BUILDING PERMIT APPLICATION

Project Address	1400 SOUTH POTOMAC, AURORA, COLORADO		**Unit #** 180
Project Name:	INVISION SALLY JOBE AT 1400 SO. POTOMAC		
Contractor Company Name	TBD	**Phone**	**Fax**
Contact Person	LEE GAGNE'	**Phone**	
Email	l.gagne@hurley-gagne.com		**Fax** na
Architect and/or Engineer Contact information for correction items		HURLEY & GAGNE', INC	
Architect or Engineer name	LEE GAGNE	**Email**	l.gagne@hurley.gagne.com
Phone	303-413-1868	**Fax**	
Owner (Required for Certificate of Occupancy) only		INVISION/SALLY JOBE	
Owner address	~~200~~ 10700 S. GEDDES, SUITE 200, ENGLEWOOD CO.		
Email	—		
Valuation / FDA:$	$150,000	**Materials Cost: $**	$75,000

Describe The Work You Will Be Doing: RENOVATING OF 1,910 SQ. FT OF A MEDICAL OFFICES BULDING, TENET FINISH RENOVATION.

NEW C.O. IS NOT REQ'D
City of Aurora Plan Review
Occ./Const. Type B / II-N SPK
Code 2009 IBC S.F. 1,900
RSN 8054446
Permit Number 14-822618/BLD

DIFFUSER DETAIL
NO SCALE

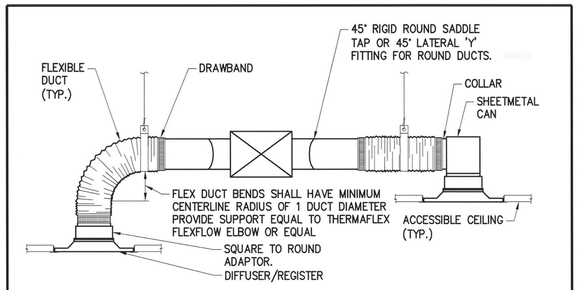
Locate receptacles a minimum of 15" AFF and locate light switches, pull boxes and thermostats etc. a maximum of 44" AFF per ANSI A117.1 308.

SUITE FLOOR PLAN - LIGHTING
SCALE: 1/4" = 1'-0"

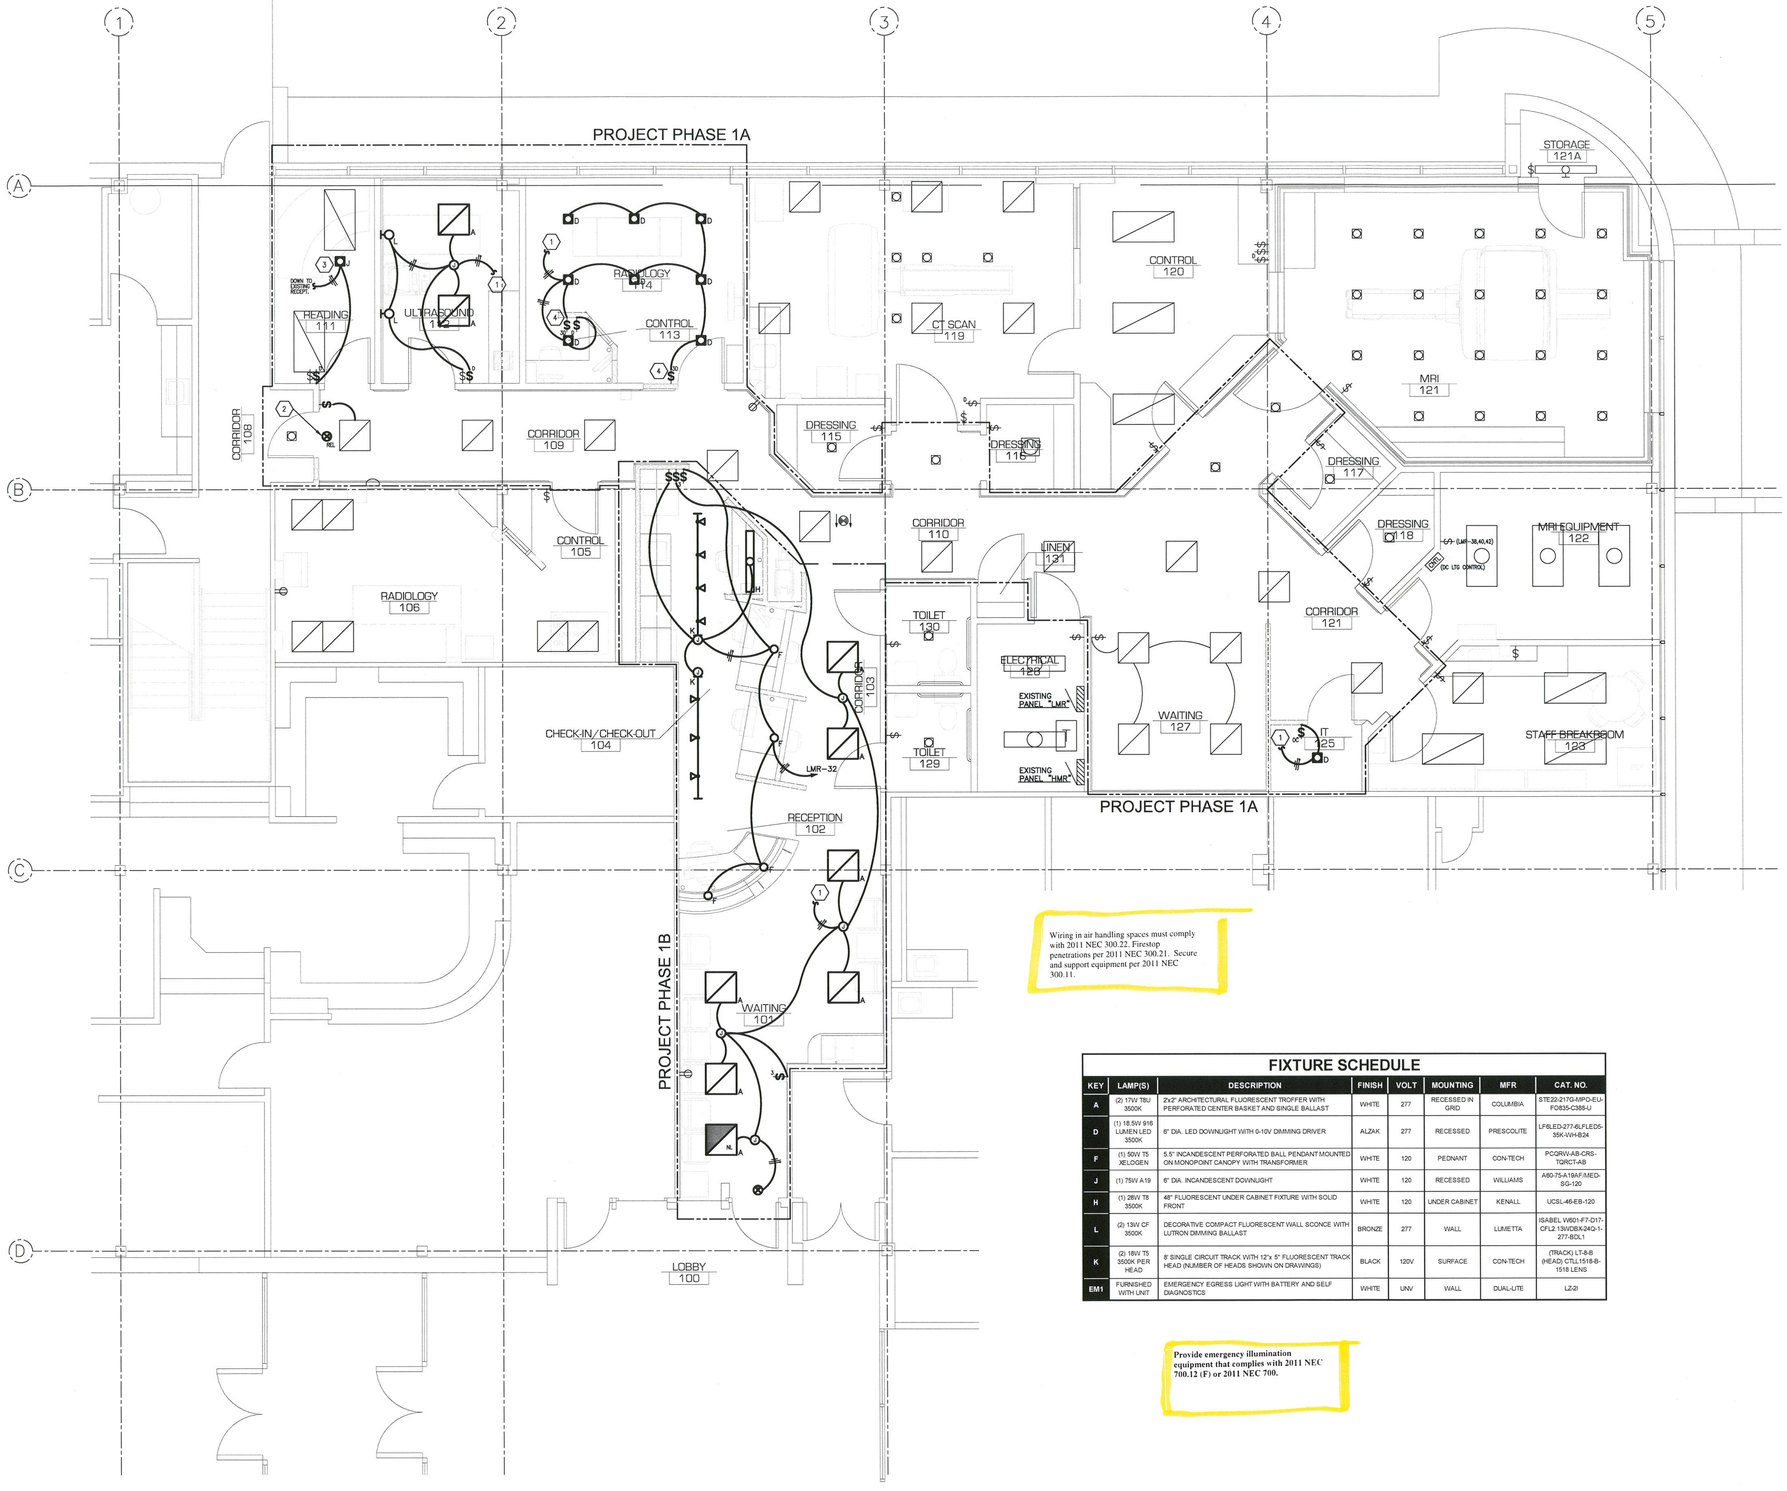
Provide emergency illumination equipment that complies with 2011 NEC 700.12 (F) or 2011 NEC 700.

SUITE FLOOR PLAN - POWER
SCALE: 1/4" = 1'-0"

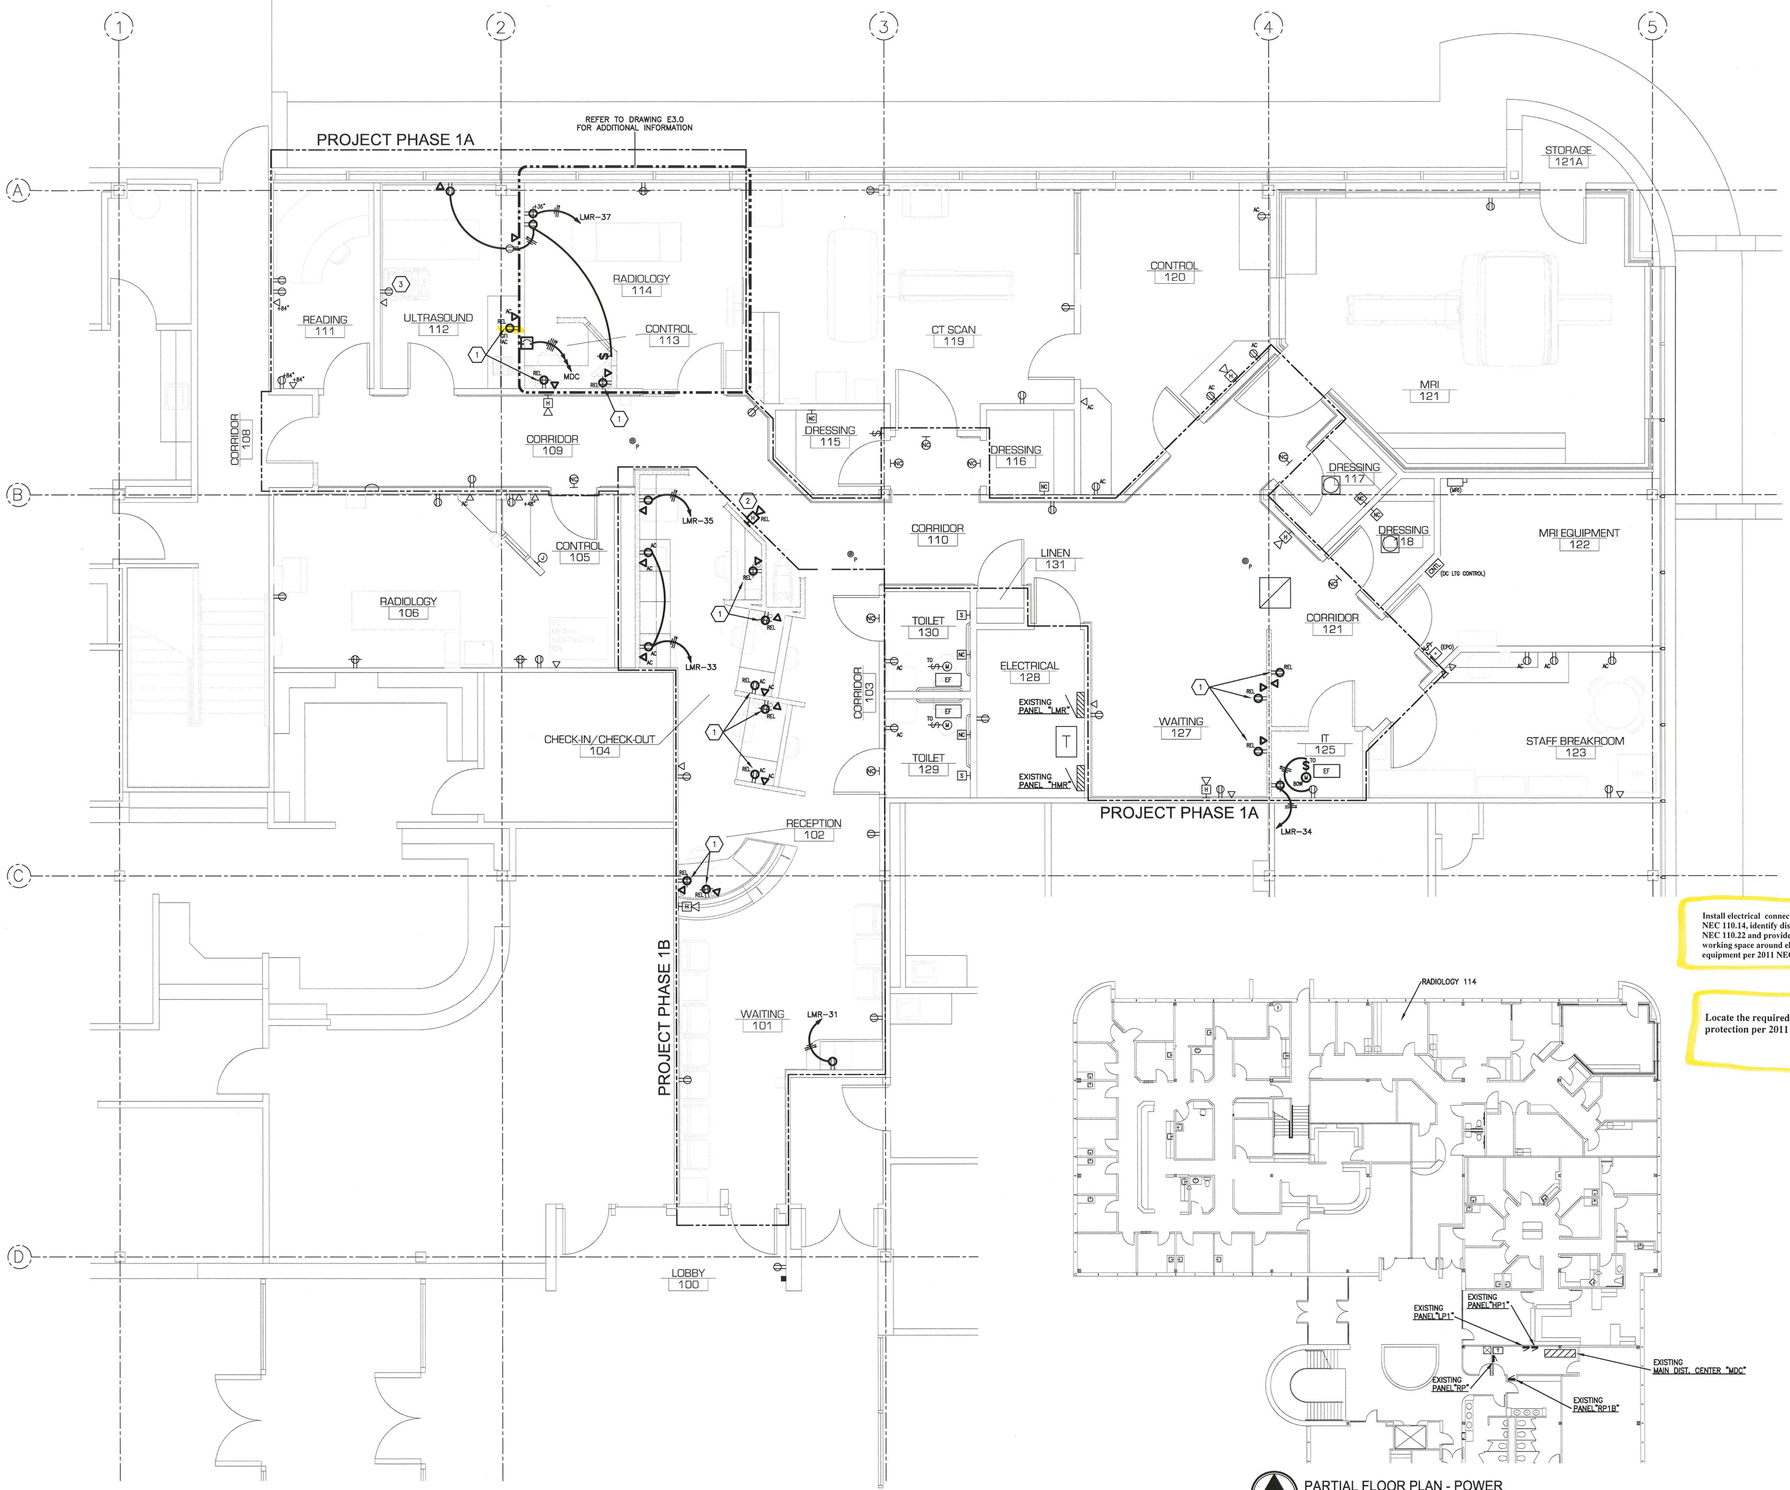
Install electrical connections per 2011 NEC 110.14, identify disconnects per 2011 NEC 110.22 and provide working space around electrical equipment per 2011 NEC 110.26

ELECTRICAL ONE-LINE DIAGRAM - EXISTING
SCALE: NONE

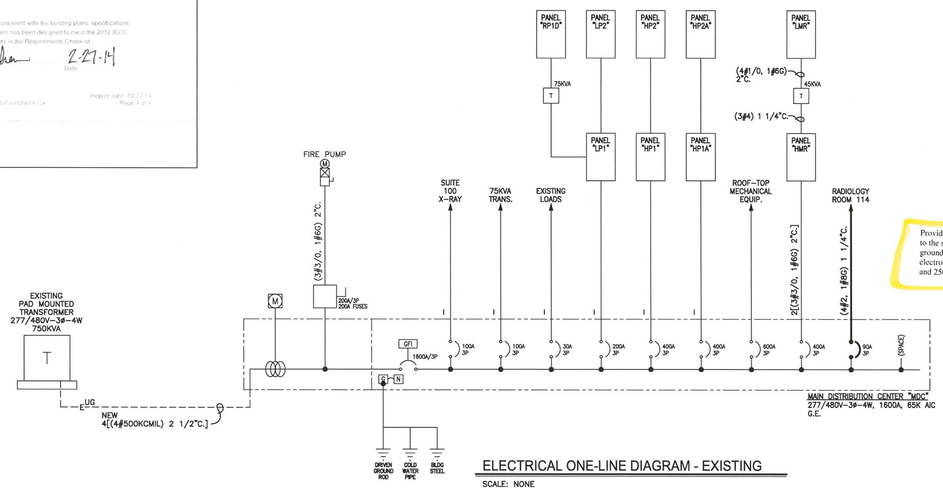
Provide a grounded electrode system bonded to the service equipment enclosure, grounded conductors, and grounded electrode conductors per 2011 NEC 250.50 and 250.104.
